SUBMITTAL IDENTIFICATION SHEET

WEBSTER UNIVERSITY ISB

123553-004 REV 1

SCIENCE EQUIPMENT ROUGH-IN
WEBSTER UNIVERSITY
WEBSTER GROVES, MO

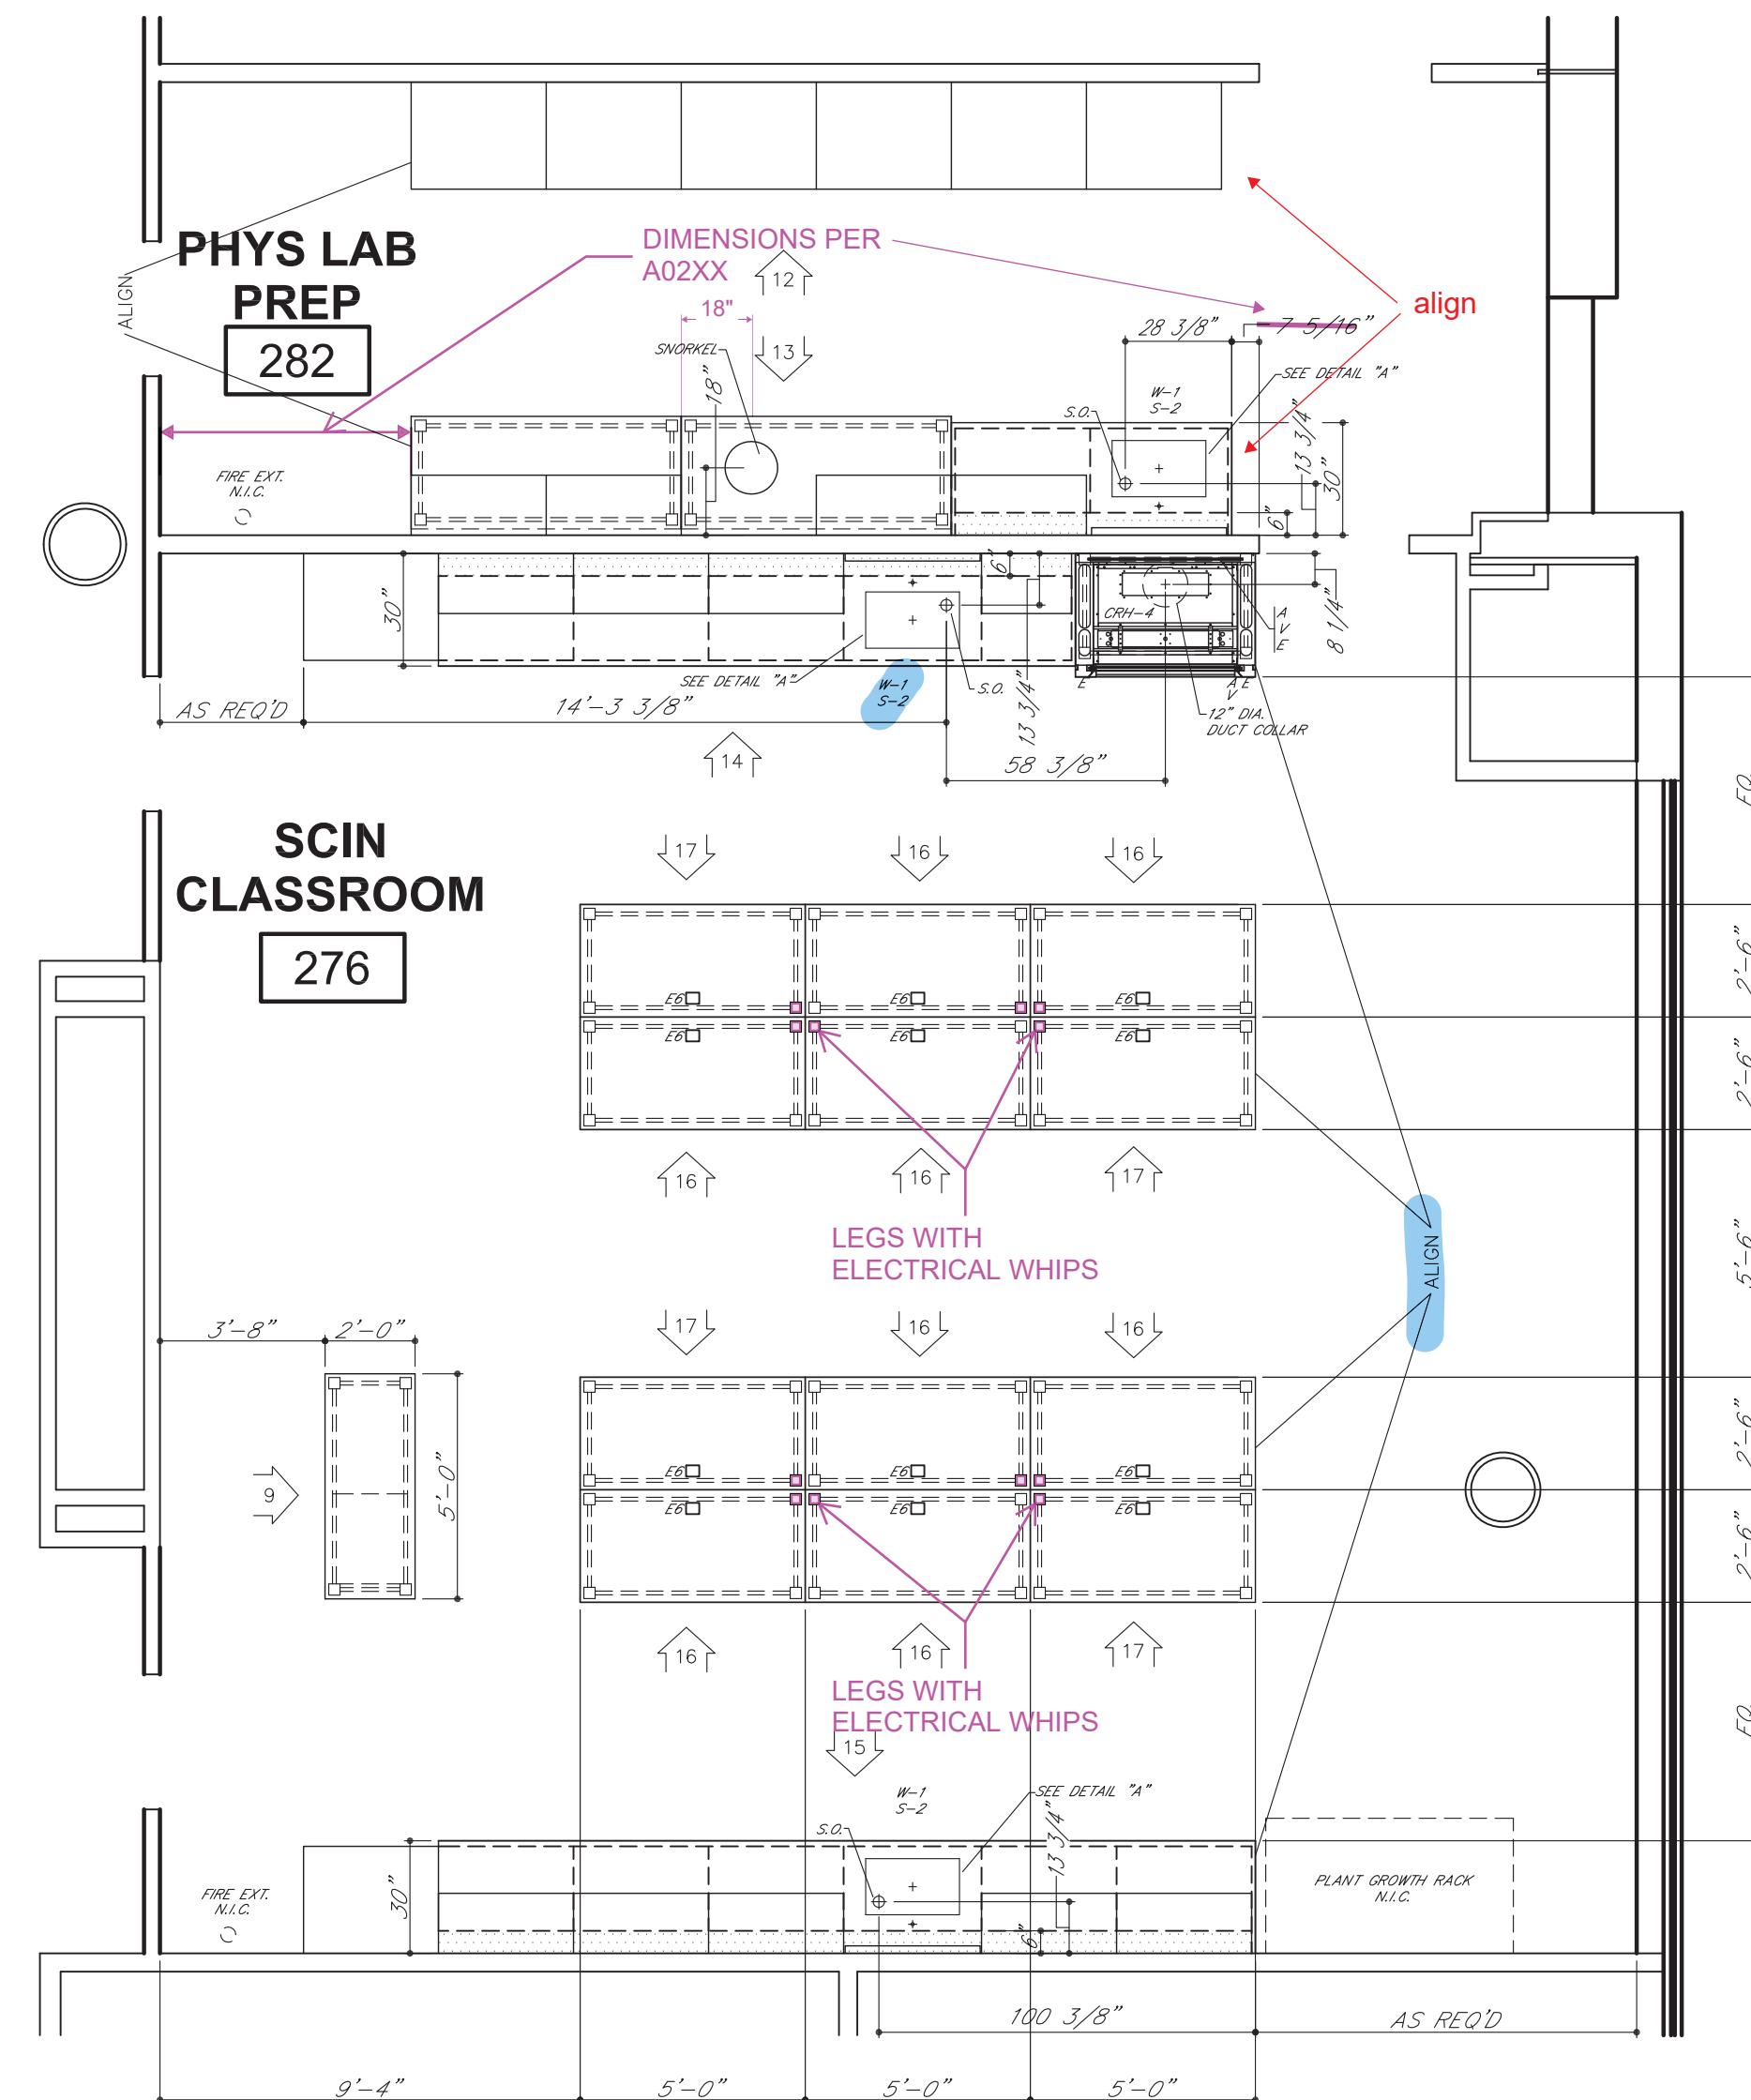
align

LEGS WITH
ELECTRICAL WHIPS

LEGS WITH
ELECTRICAL WHIPS

PARTIAL FLOOR PLAN
LEVEL 04 - AREA A- CHEMISTRY WEST

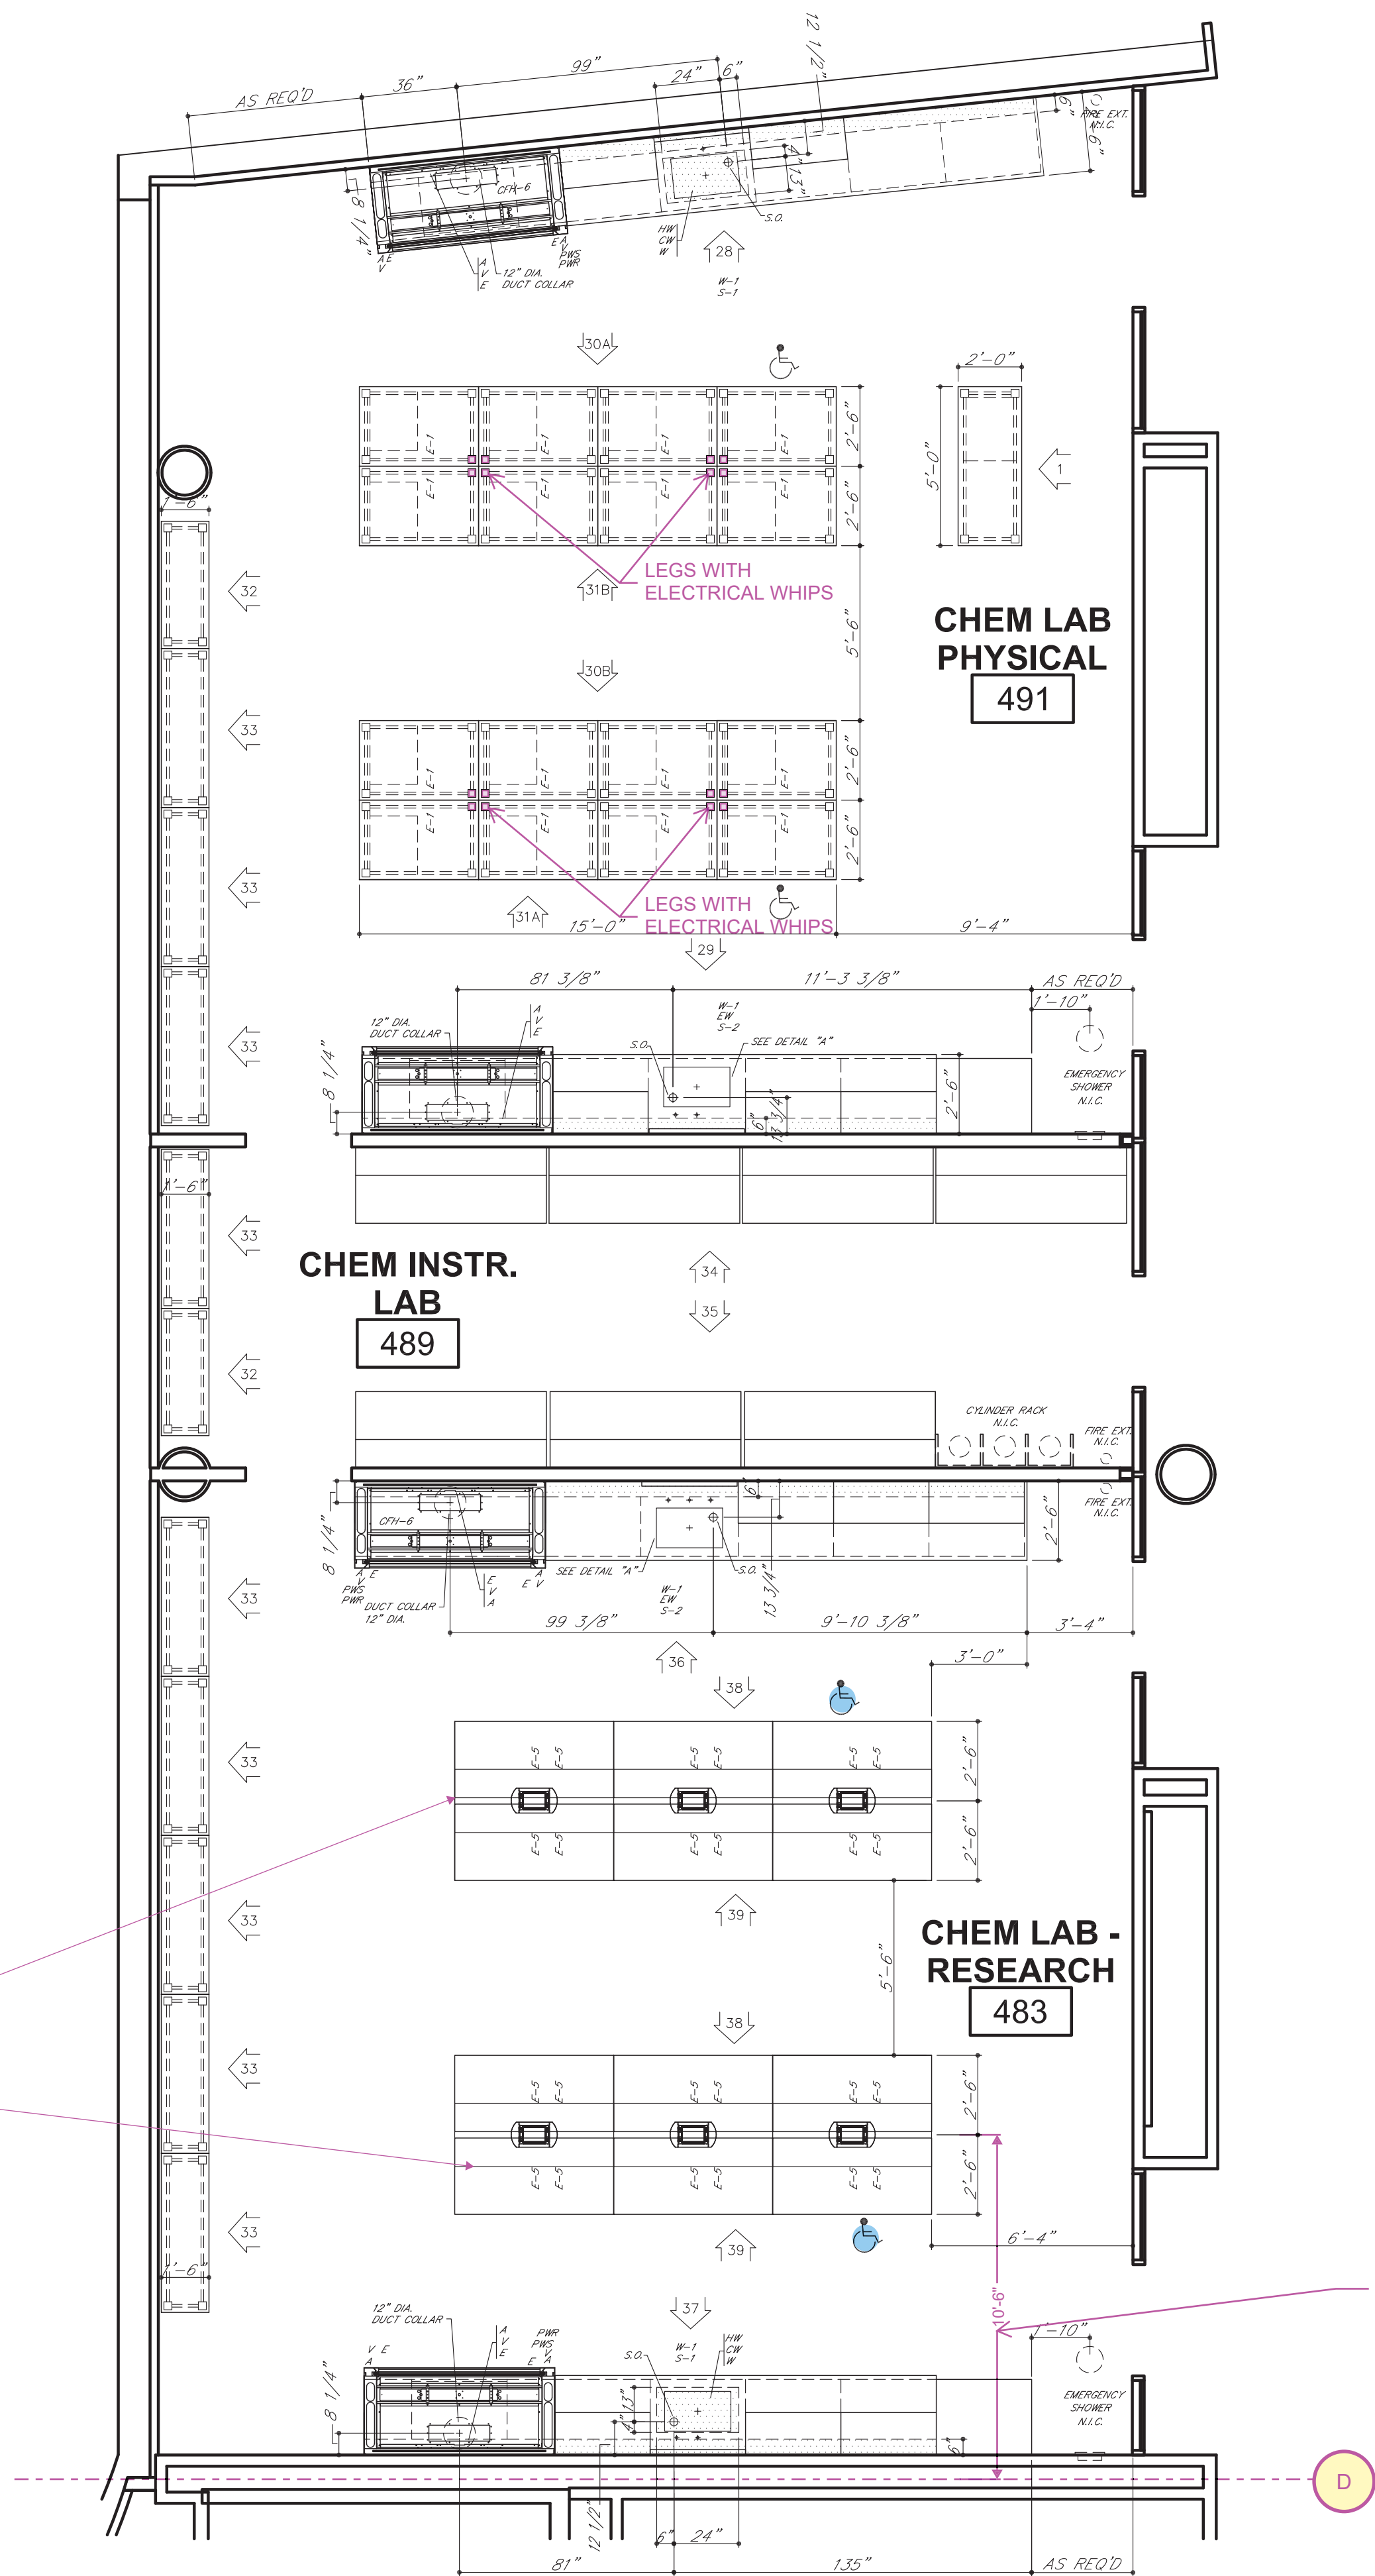
PROVIDE FIXTURES ON OVERHEAD SERVICE CARRIER PER DIMENSIONS ON A02xx DRAWINGS. TYPICAL FOR ALL OVERHEAD SERVICE CARRIERS IN THE PROJECT.

GC TO COORDINATE CASEWORK LOCATION FOR ALL LAB CASEWORK PER A02xx DRAWINGS, TYPICAL.
